STRUCTURES DESIGN BULLETIN 13-01

ROADWAY DESIGN BULLETIN 13-02

SUBJECT: Median Barrier Mounted Overhead Sign Structures

This bulletin revises and expands on the Department's policy for attachment of overhead sign structures to concrete median barrier walls and revises *Design Standards* Index 410.

OPTION 1

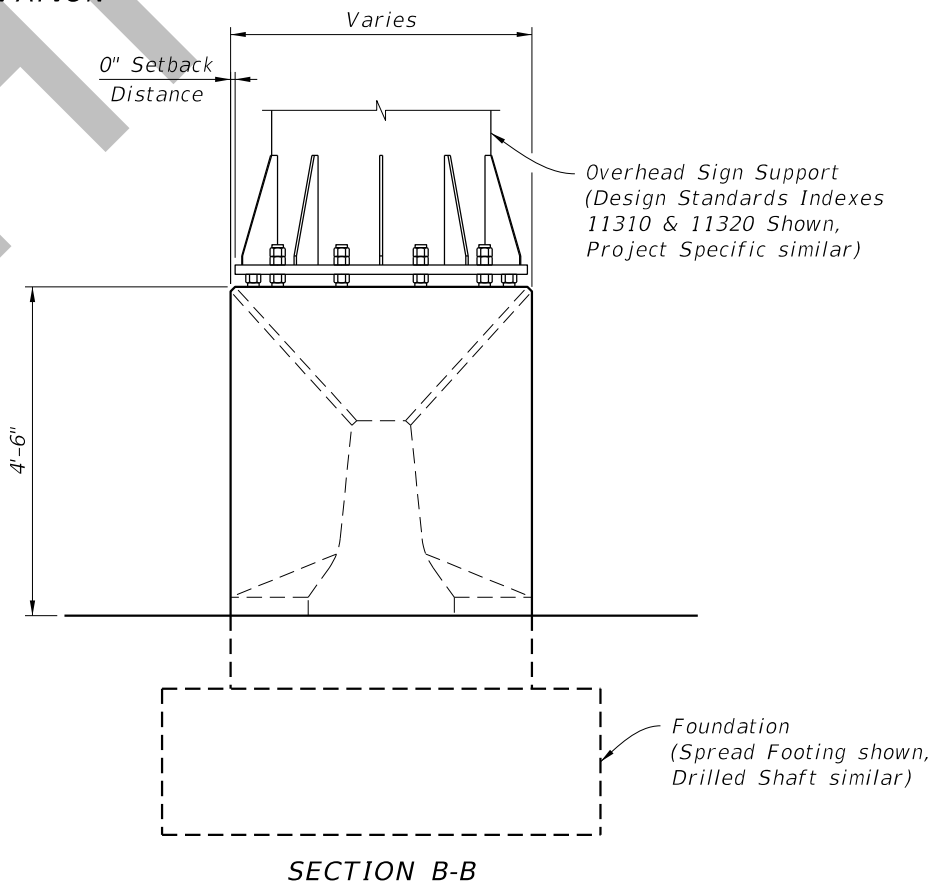
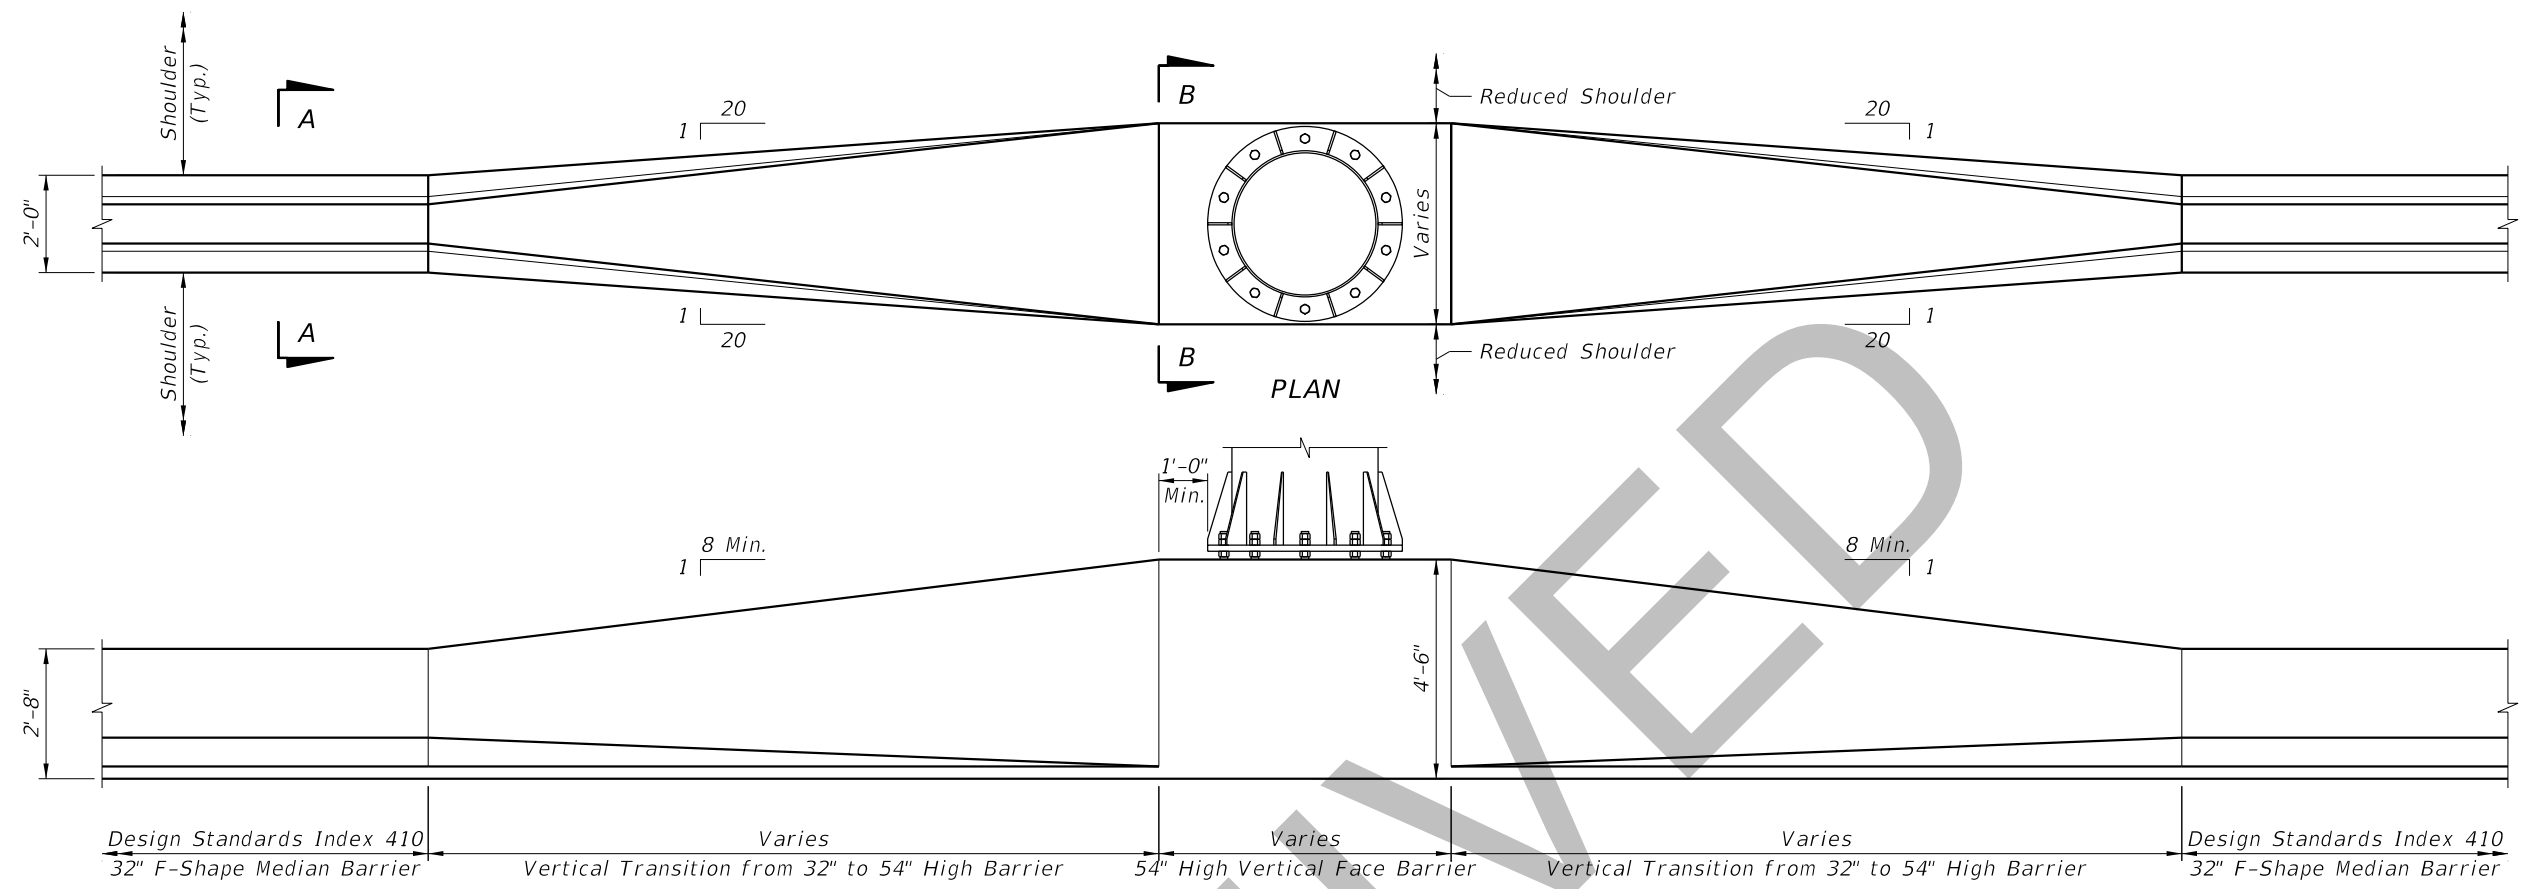
In Option 1, the height of the median barrier wall is transitioned from 32" to 54" and the shape is transitioned from the standard F-shape to a vertical face over a length of 15'-0". The base plate and anchor bolts of the sign support upright are located at the top of the 54" tall section of vertical face median barrier wall. A setback distance of 0" to the base plate is utilized on both sides of the 54" tall median barrier wall which is consistent with that shown for Index 425 in *PPM* Volume 1, Figure 7.1.2.1. The median barrier wall and the top of the 54" tall vertical face section are a constant 2'-0" width which limits the maximum base plate diameter to 2'-0". This in turn limits the maximum diameter of the sign support upright. Anchor bolt and reinforcing steel placement within this section of wall may further limit the maximum diameter of the upright. Project specific details for the median barrier wall and sign support foundation are required and must be included in the Plans. *Design Standards* Indexes 11310 or 11320, or a project specific multiple upright sign support structure may be used. Details must be included in the plans for project specific multiple upright sign support structures. Consider the need for vandal protection guards when using multiple upright sign support structures. This option does not reduce the width of the inside shoulders.

OPTION 2

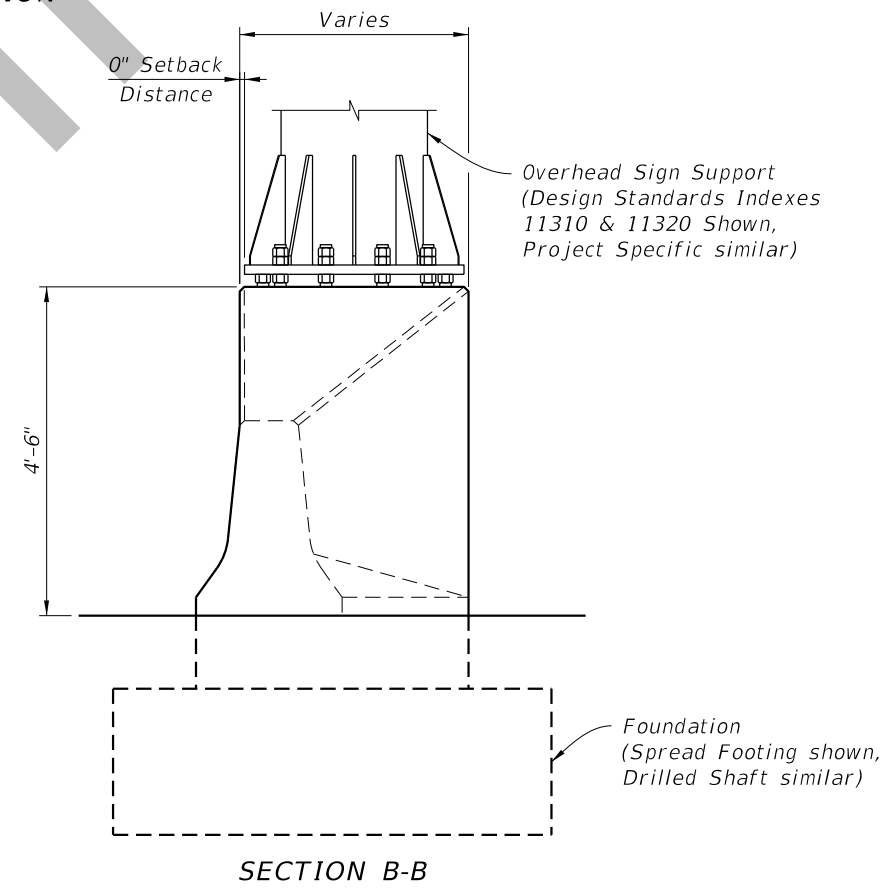
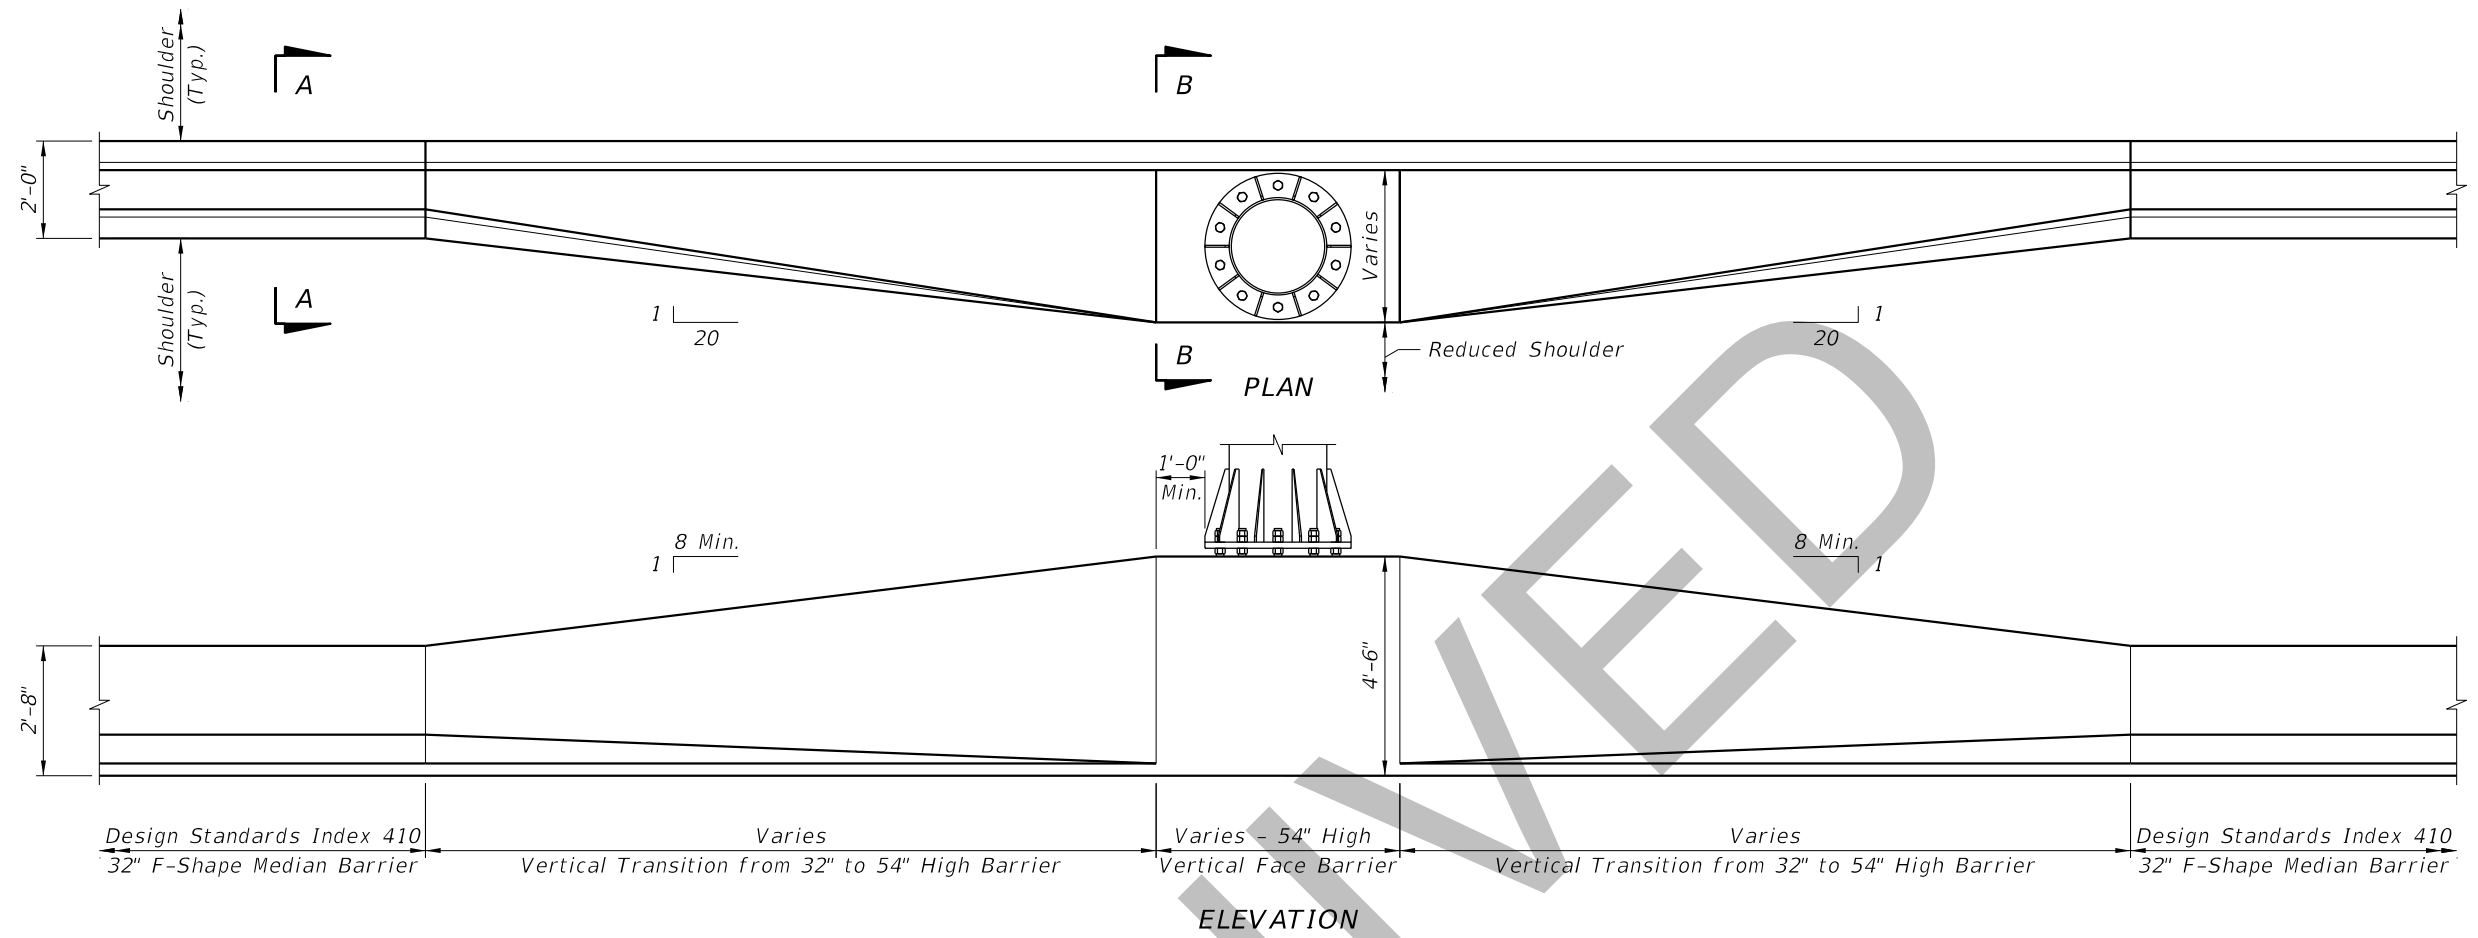
Option 2 is similar to Option 1 except that the median barrier wall is flared out to accommodate larger diameter sign support uprights and base plates. This option reduces the width of the inside shoulders on both sides of the median barrier wall. A Design Exception for shoulder width may be required.
